Access Compliance Report

Public Rights-of-Way

(Curb Ramps)

Intersection ID: 30146	Main Street: HEMBY_WOODS_DR	Cross Street: RAIN_CREEK_WY	Location: SE
ADA ID: AB3EA0597C2E	Ramp Type: Perp	Initial Pass/Fail: Fail	Overall Compliance: No
Severity Score: 10			
Codes/Mitigation Info/Possible Solution		Field Measurements/Component Compliance

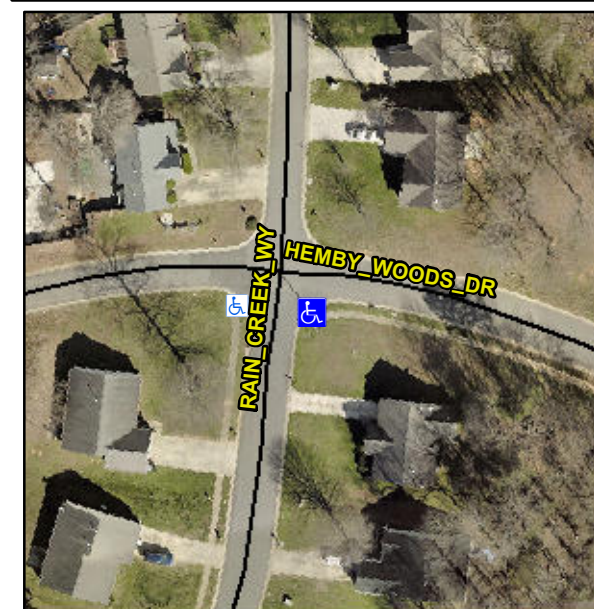
Not Found, R304.5.1, R304.5.3

Compliance	Description	Data	Compliance	Description	Data
N/A	Ramp Length (in)	97.0	Yes	Ramp Slope (%)	6.6
No	Ramp Width (in)	46.5	No	Ramp XSlope (%)	2.8
N/A	Flare Type LT	N/A	N/A	Flare Type RT	N/A
N/A	Flare Slope LT (%)	N/A	N/A	Flare Slope RT (%)	N/A
N/A	Flare Traversable LT?	N/A	N/A	Flare Traversable RT?	N/A
N/A	Landing Length (in)	N/A	N/A	DWS Provided?	N/A
N/A	Landing Width (in)	N/A	N/A	DWS Contrast?	N/A
N/A	Landing Slope (%)	N/A	N/A	DWS Length (in)	N/A
N/A	Landing X Slope (%)	N/A	N/A	DWS Full Width?	N/A
N/A	Landing Curb? (Y/N)	N/A	N/A	DWS Offset (in)	N/A
N/A	Shared Landing?	N/A			
N/A	Gutter Ponding?	N/A	N/A	Gutter Slope (%)	N/A
N/A	Gutter Lip Ht (in)	N/A	N/A	Gutter X Slope (%)	N/A
N/A	Painted X Walk1?	No	N/A	Painted X Walk2?	N/A
	X Walk 1 Direction	To W		X Walk 2 Direction	N/A
N/A	X Walk 1 Width (in)	N/A	N/A	X Walk 2 Width (in)	N/A
	X Walk 1 Slope (%)	3.8		X Walk 2 Slope (%)	N/A
	X Walk 1 X Slope (%)	0.7		X Walk 2 X Slope (%)	N/A

Remove & Replace Entire Ramp.
